(IDLE) SAUGUS–ELIZABETH LAKE–FILLMORE 66kV T/L

PROPOSED CONSTRUCTION (LOCATION)
MAT 119–POLE OH REPL: 4089526E & 4510200E
HWY 126 PP 1680' N 5580'E//B/O RANCHO CAMULOS
PIRU, CA

DESIGN NO. 1771376_0.01

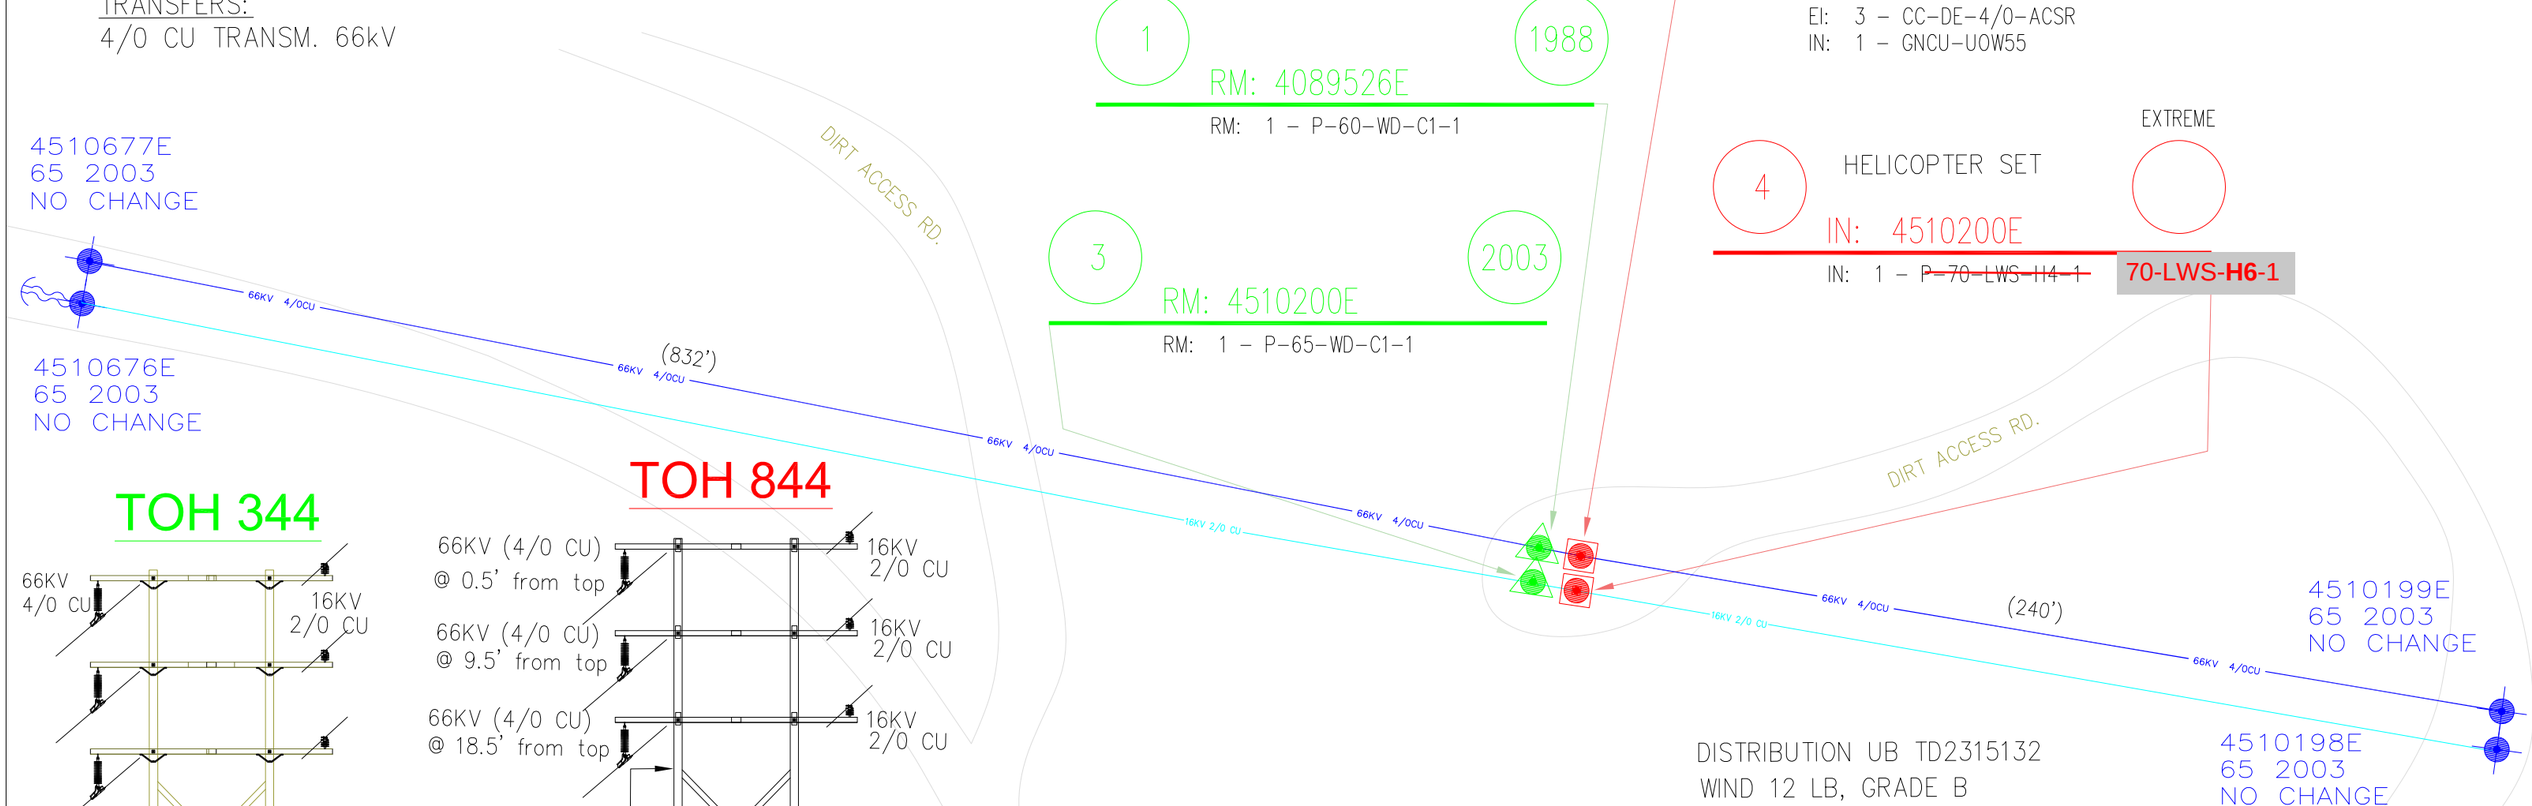
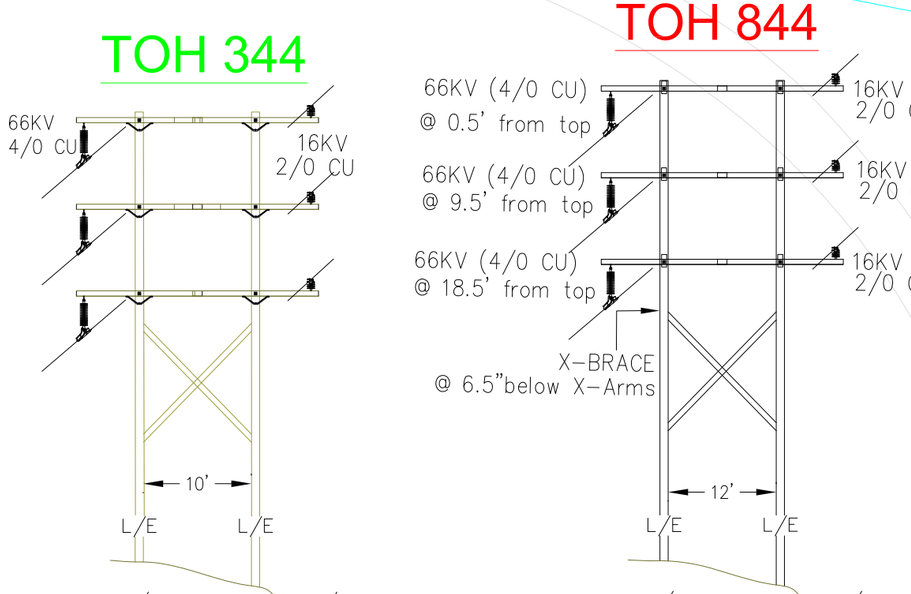
6-04-2025: Due to material availability poles are being redlined to class H6.
- T. Devestern
